UNIT 4 | D04 DINING WEST WALL

PANEL + PICTURE-FRAME COORDINATION | 01 NOV 2026 | R1

REVIEW ONLY — NO FRAMING OR CUT RELEASE

WALL ELEVATION • NOT TO SCALE

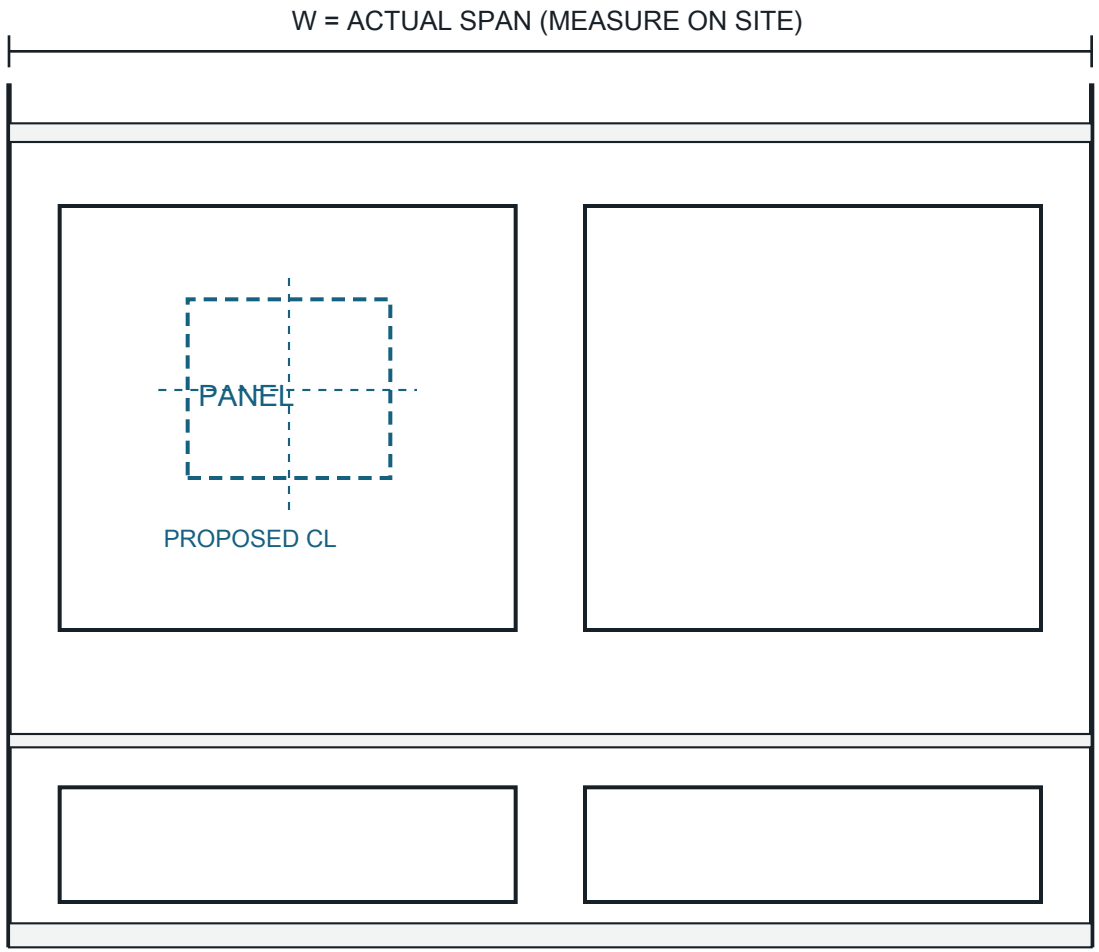
W excludes the transom door on the perpendicular wall.

Upper frames: 41–99 in AFF; lower: 13.5–31 in AFF.

Vertical dimensions are proposed, not field measurements.

Dashed panel is schematic only; not a cover or framing outline.

D04: window casing to right inside corner; transom door is on adjacent wall.

x = W/4 + 1 in from left datum

Target CL = 65 in AFF; can/cover TBD

Finished-floor / subfloor offset: UNKNOWN.

4 + B + 4 + B + 4 = W

B = (W – 12) / 2; numeric W unknown.

1. Actual box AND matching trim in hand.
2. Verify W, wall depth, studs, floor datum.
3. Electrician confirms cover removal, door swing, working space and feeder.
4. Rough opening: NOT DETERMINED.
5. Coordinate D5 and D02 cabinet return.
